# Multi-Trades and Digital Technology Hub at TAFE Meadowbank Modification 2

Modification for the construction of two additional levels to the approved two storey car park on See Street at TAFE Meadowbank.

State Significant Development Modification Assessment  
(SSD 10349 MOD 2)

**Figure 3 |** Nearby local heritage items (Source: RLEP 2014)

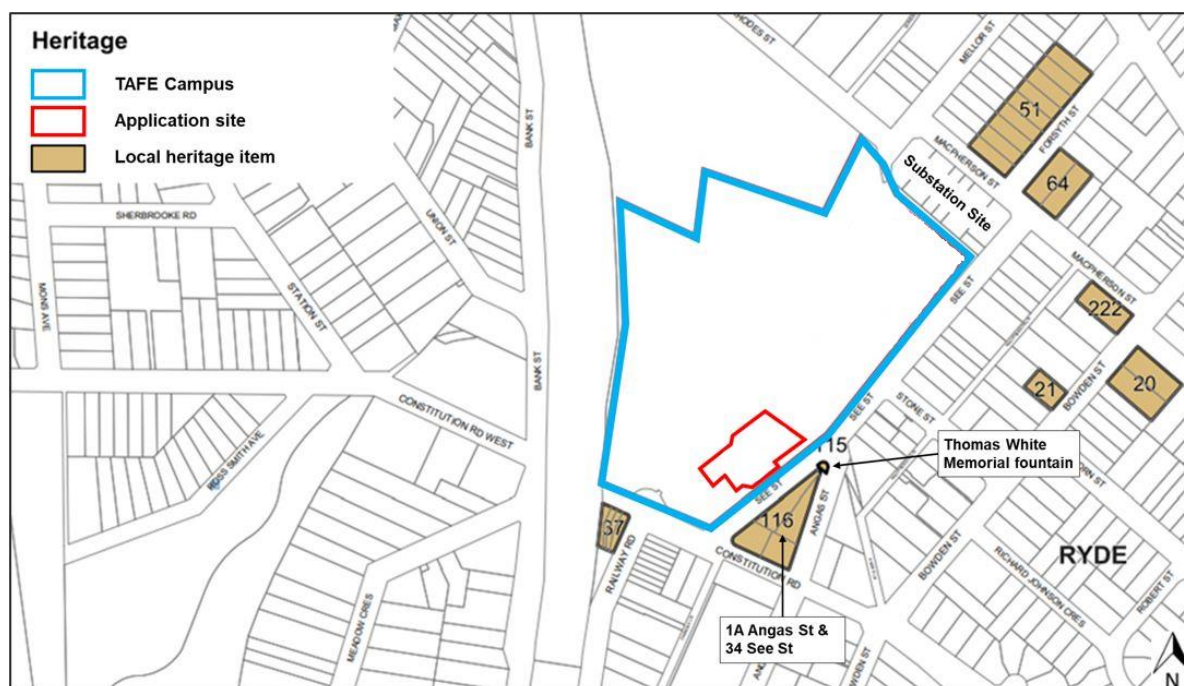
- The proposed car park is located on the opposite side of See Street, approximately 25 metres from two locally listed heritage items. These being a fountain (LEP 115) located on the corner of Angas and See streets and attached dwellings (LEP 116) or 'The Laurels' located at 1A Angas and 34 See Street (refer to **Figure 3**).

- The Department has reviewed the relevant documents and understands that there is visual separation between See Street and the existing carpark and the TAFE precinct with mature hedges and trees lining the boundary. The heritage assessment for the original consent notes that the locally listed heritage items have been subject to existing cumulative visual impacts by adjoining developments and the broader TAFE and school precinct. Therefore, the additional two storeys to the car park are unlikely to impact the visual amenity of the surrounding heritage items.

- The Department notes the height and appearance of the car park has been sympathetically designed to fit within the existing scale and character of the TAFE Campus buildings. In addition, the carpark would be located approximately 25m-30m away from the heritage items. This setback coupled with landscaping softens the visual impact of the car park.

- The Department concludes the proposal would not have an adverse impact on the significance of the heritage items on See Street and that the additional storeys of the car park are considered appropriate.

**Figure 5 | Eastern (See Street) elevation of the carpark as proposed in this modification**

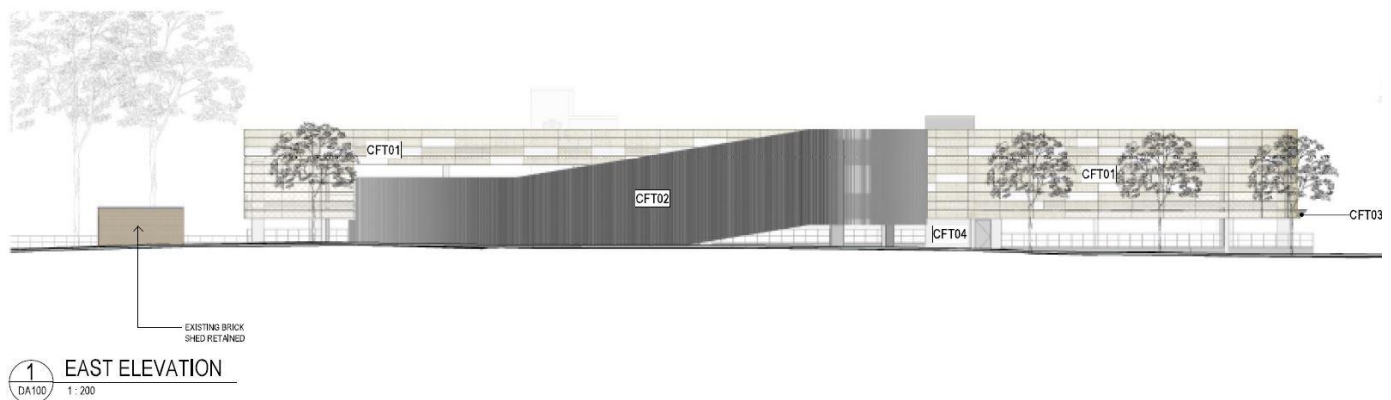
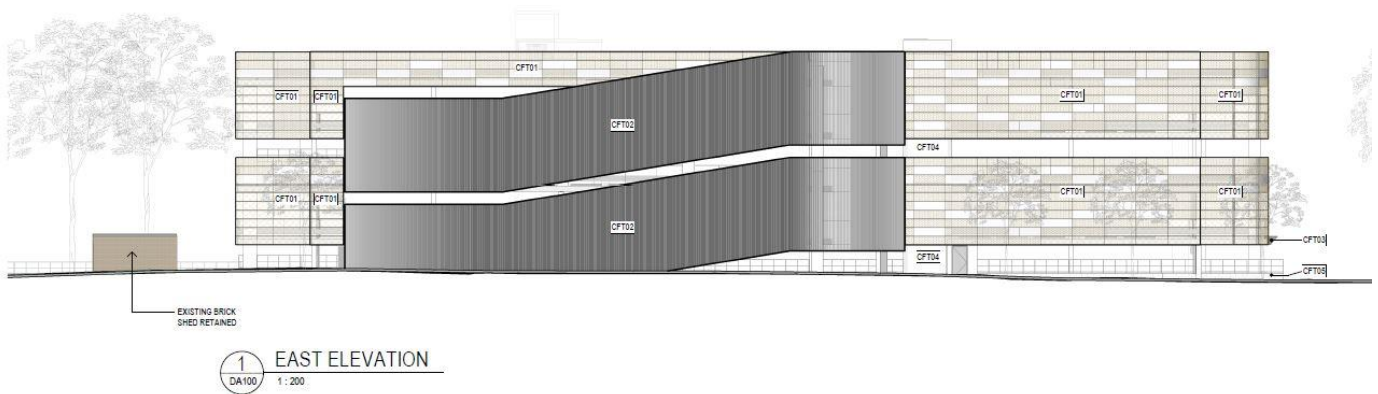
The approved car park comprises a two-storey structure consisting of three internal car parking levels and an approved maximum height of RL 34.35m (see **Figure 4**). The proposed amendments will increase the height by two additional levels, resulting in a four storey structure and five levels of parking with a maximum height of RL 41.15m. This equates to a 6.8m increase in building height (see **Figure 5**).

- The modification application proposes the addition of two internal levels of car parking to the approved three internal levels car park structure (proposing a change from two storeys to four storeys).

- The Department has assessed the architectural plans and is satisfied that the height and design are appropriate in the site context and would not have a detrimental visual impact on the character of the surrounding area, setting or significance of nearby local heritage items.
